Independent Assessment Report

Section 4.55 Application: 12A and 14-26 Wattle Street, Pyrmont

File Number: D/2023/97/A

Figure 9: Level 01

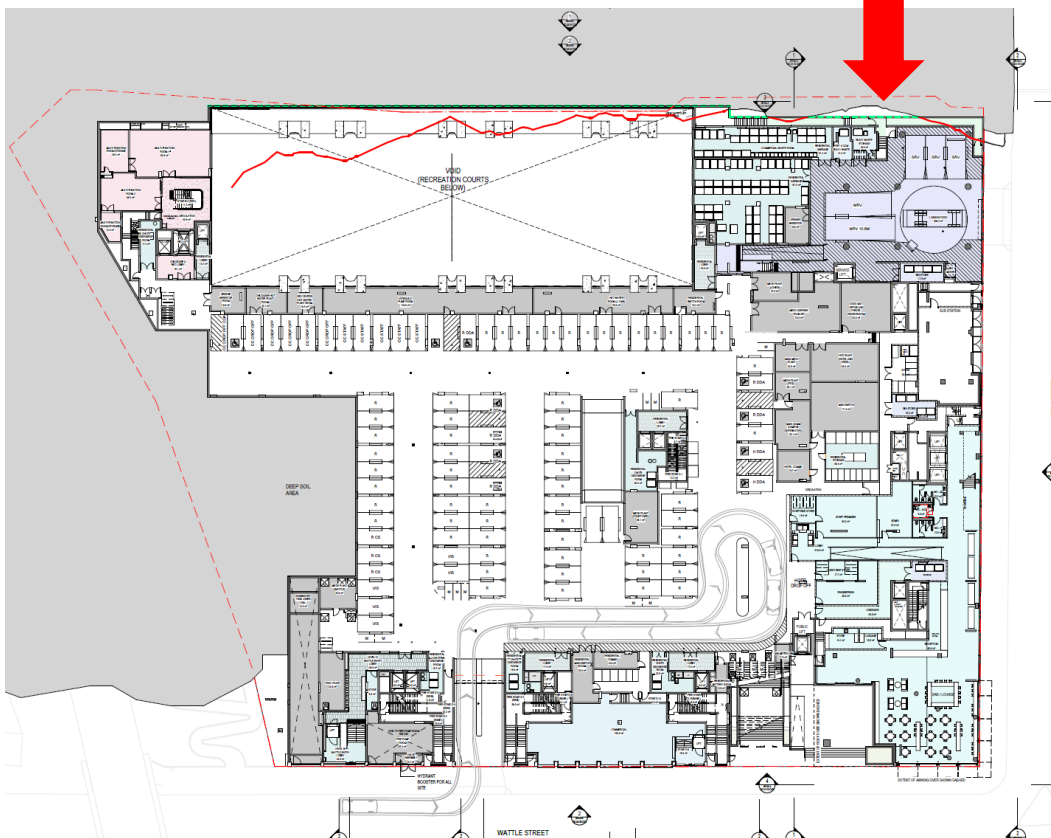
31. Modification of consent conditions (1), (2), (3), (4), (8), (10), (11), (48), (49), (56), (57), (59), (60), (61), (62), (63), (64), (157) and new conditions (177) and (178).
32. **Table 1** compares the Original Consent (D/2023/97) with the section 4.55 modification application (D/2023/97/A). Plans, elevations and photomontages comparing the Original Consent and section 4.55 modification application follow at **Figures 9 to 25**.

Figure 26: Fig Street Building: Fig Street elevation showing proposed increase in building height

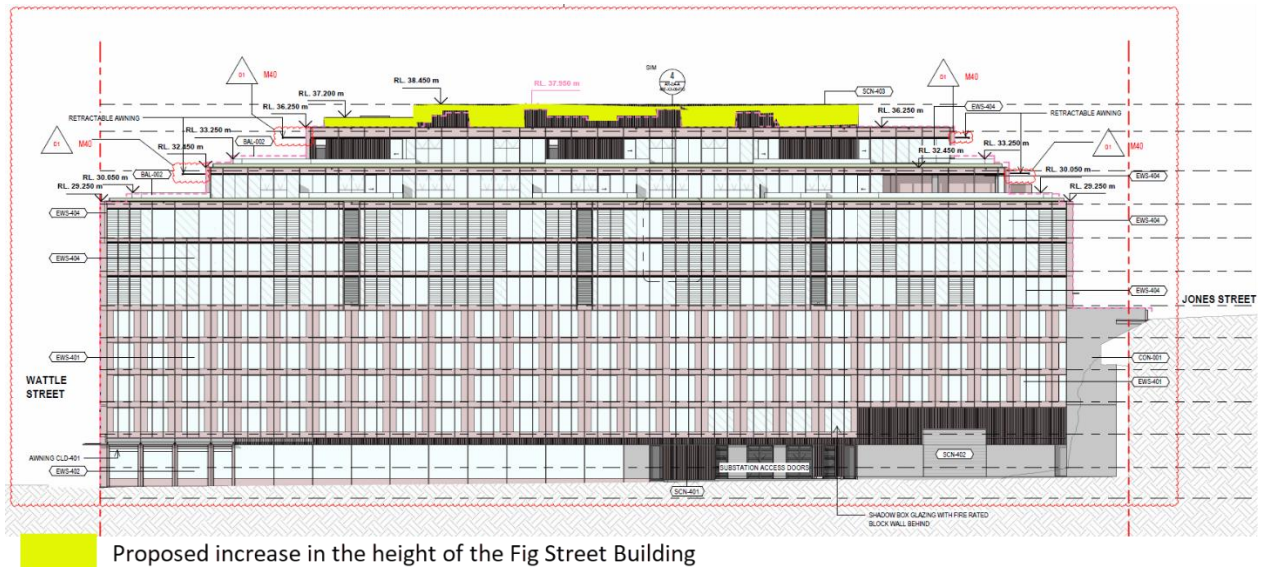
65. **Figure 26** illustrates the proposed increase to the height of the Fig Street Building. **Figure 27** illustrates the proposed reduction in the width of the Fig Street Building. **Figure 28** overlays the envelope of the approved development (D/2019/649/B and D/2023/97/A) and the proposed modification applications (D/2019/649/C and D/2023/97/A).

Figure 29: Fig Street Building: Layout of modified plant room

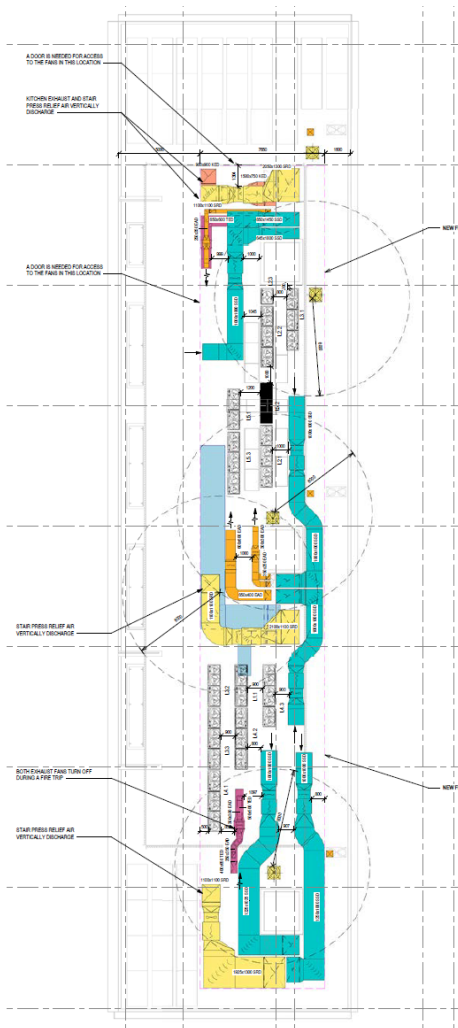
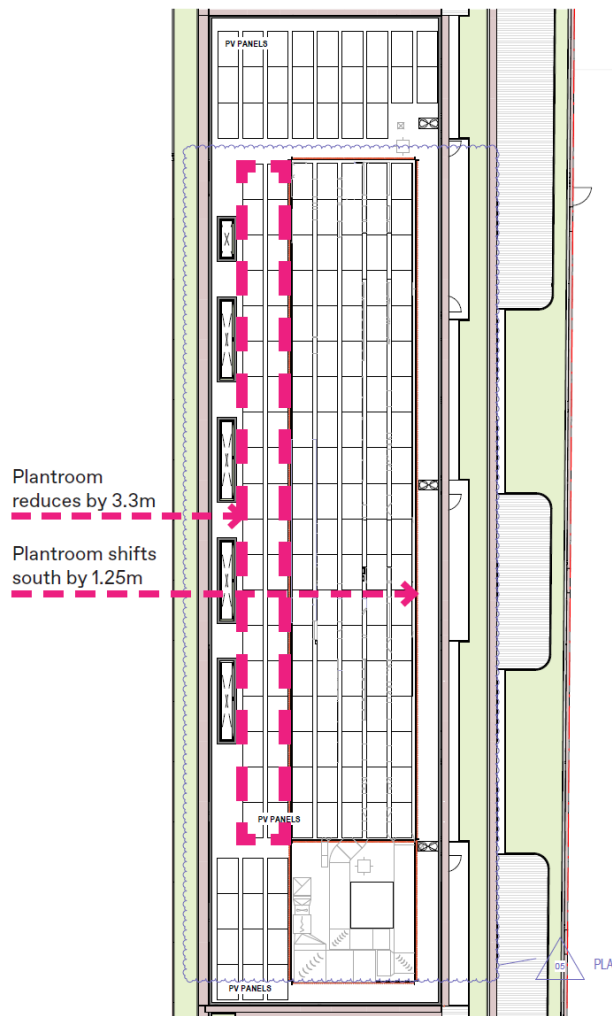
- (c) An integrated and screened plant room is proposed and the size of the plant room size was reduced (-85m²) in response to Council's RFI#1. Plans have been provided that demonstrate that the modified plant room is fully utilised (see **Figure 29**).

Figure 31: Privacy protection measures - screens: Fig Street Building to Wattle Street Building

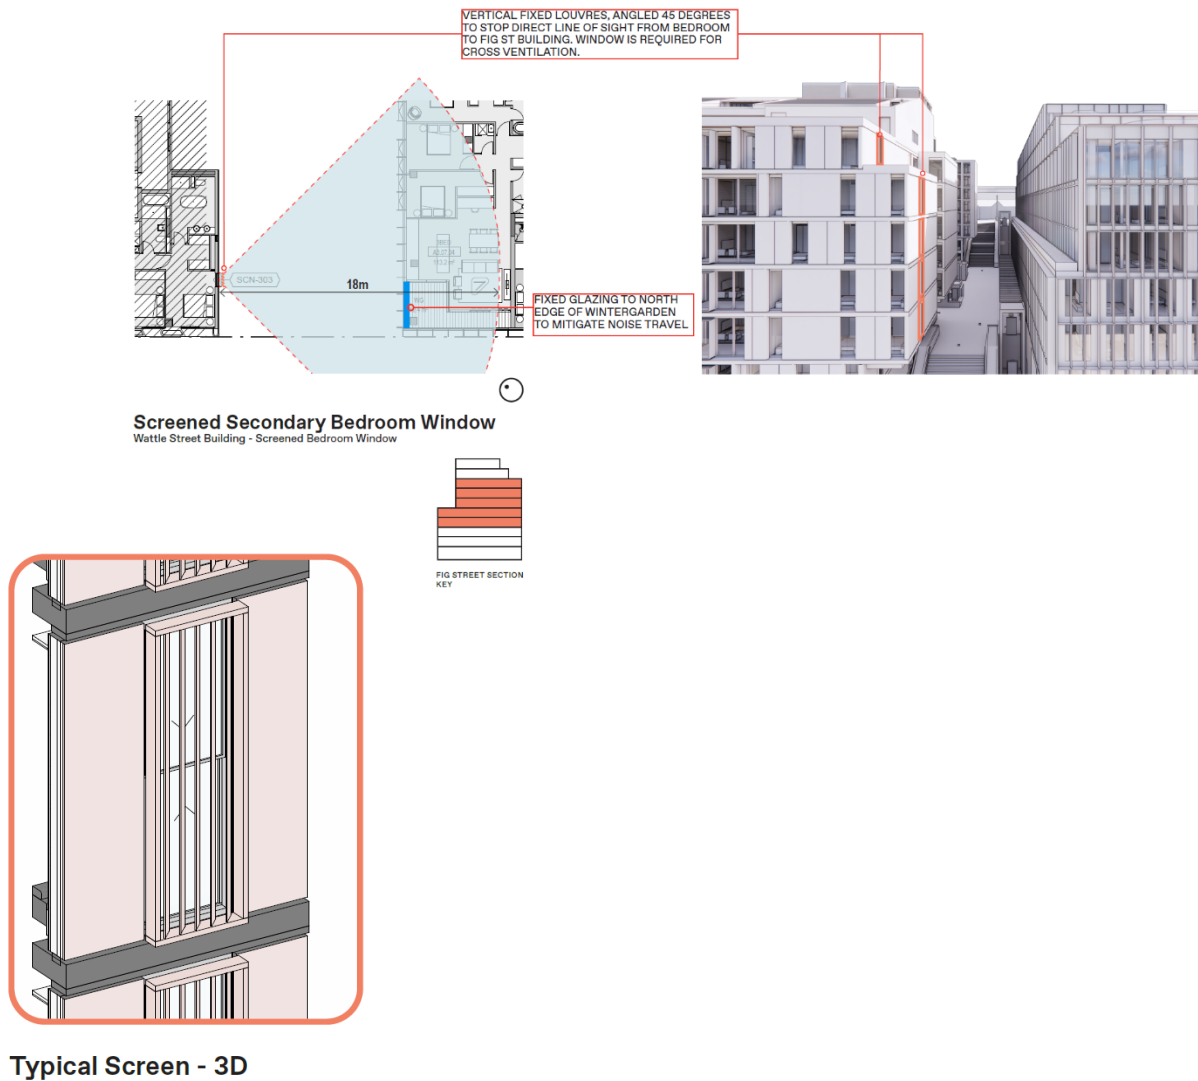
75. Consistent with these notations, the architectural plans submitted with the modification application (D/2023/97/A) provide appropriate visual and acoustic privacy protection measures in the locations where Fig Street Building separations do not meet the ADG design criteria. **Figures 31 to 37** illustrate some of the proposed privacy protection measures including fixed glazing, solid facades, louvred screens and non-trafficable planters. Additional privacy protection measures (where non-compliant separations are proposed) are to be provided to the Wattle Street Building and Jones Street Building (as set out in modification application D/2023/97/D which is under assessment).

77. Modification of condition (2) is recommended to require the submission and approval of detailed plans illustrating the design of all screens, grilles and other privacy protection measures prior to the issue of a construction certificate for above ground works

Figure 38: Natural ventilation - acoustic solutions: West, East and South Elevations

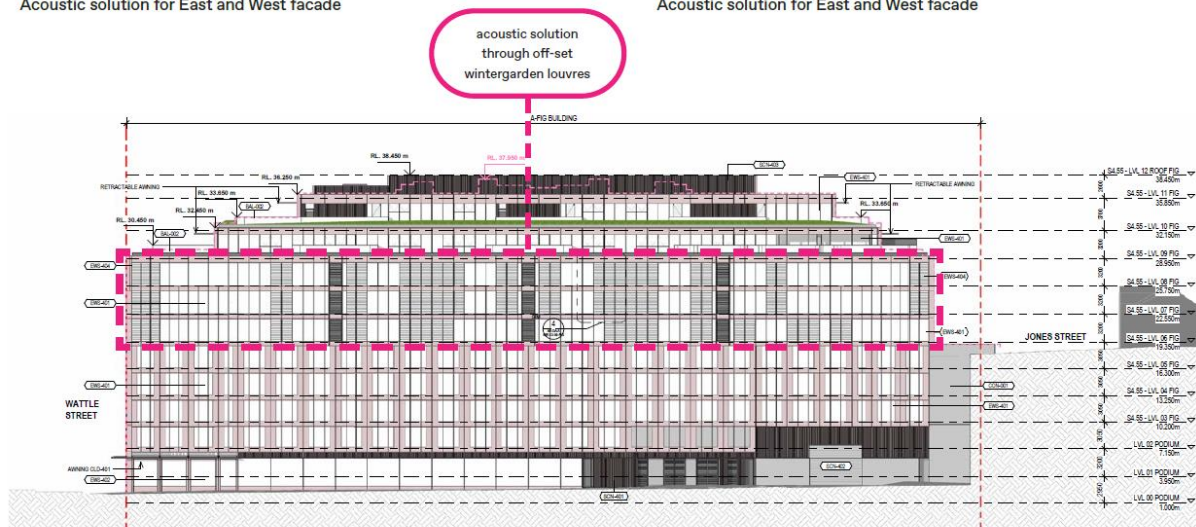
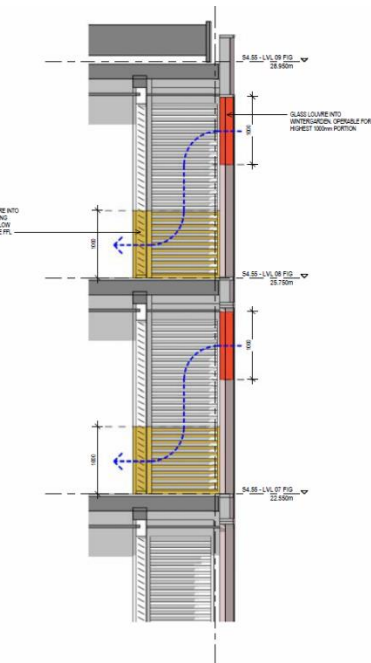
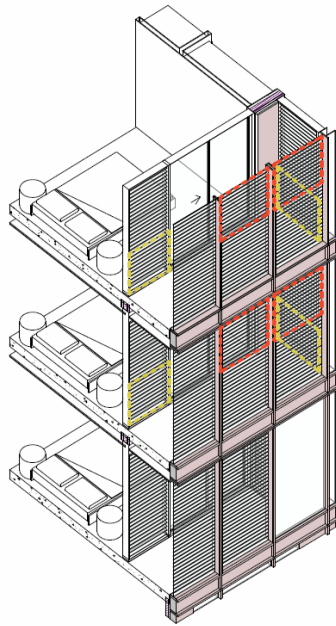
81. Proposed wintergarden treatments are illustrated at **Figures 38, 39 and 40**. Both the modified acoustic report and natural ventilation report will be approved as part of the modified consent to ensure that wintergardens are constructed and installed in accordance with the specific details in the specialist reports. Recommended new Condition (176A) requires the installation of a plaque explaining how the wintergardens mechanism can be operated in all dwellings that rely on wintergardens for acoustic amenity and natural cross ventilation.

83. Council's Urban Designer considered that the proposed acoustic and natural cross ventilation solution, subject to conditions, are satisfactory.

Figure 41: Sun shading: Proposed Level 09 and 10 retractable awnings to private open space

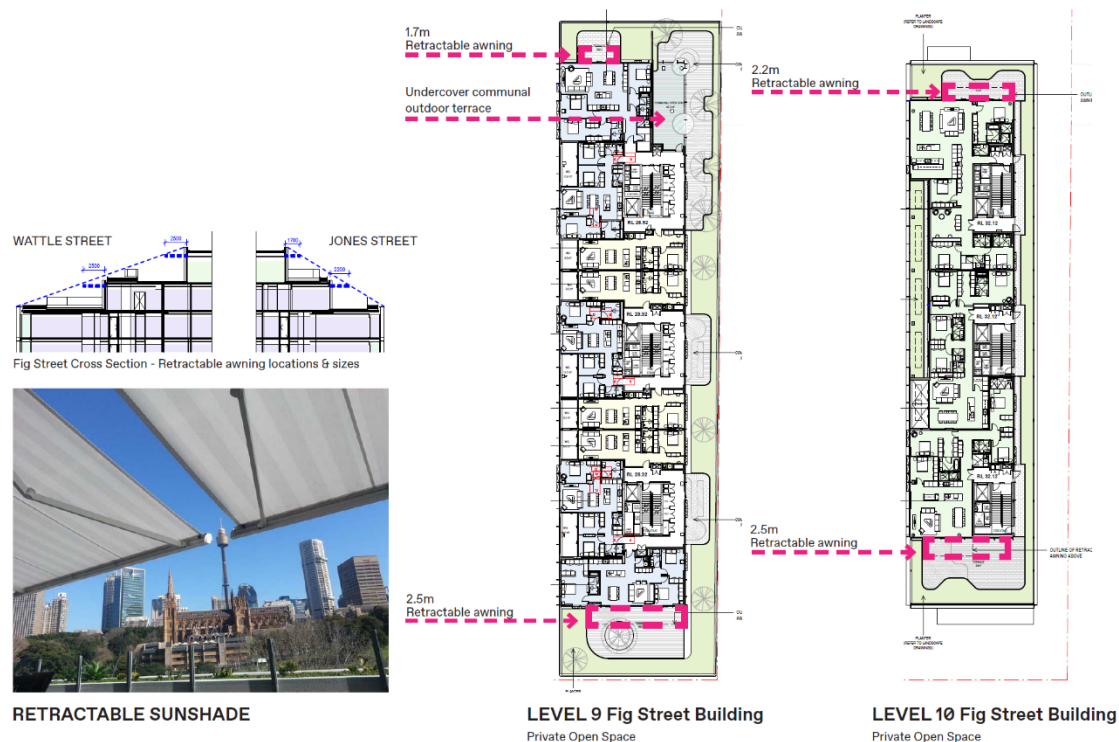
86. In accordance with Council's RFI#1, the applicant has proposed sun shading to the east and west facing Level 09 and 10 private open spaces (in the form of retractable awnings fitted with a wind sensor and weather station) (see **Figure 41**). The location/size of the proposed awnings ensures that there would be no changes to the shadow analysis (see overshadowing discussion above).

Figure 42: Fig Street Building: Subterranean hotel rooms

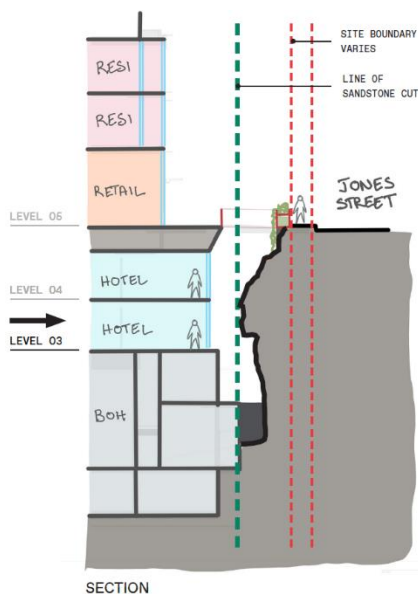
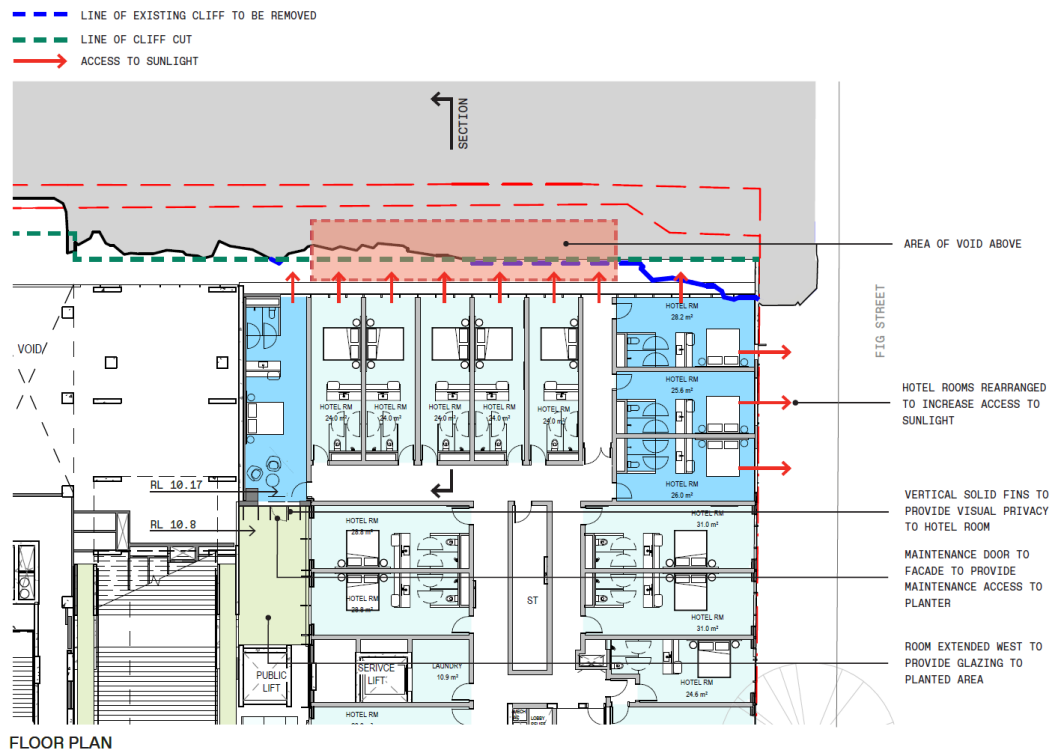
(see **Figure 42**)

88. Council's Urban Designer considered the proposed hotel room changes, subject to conditions, to be satisfactory.
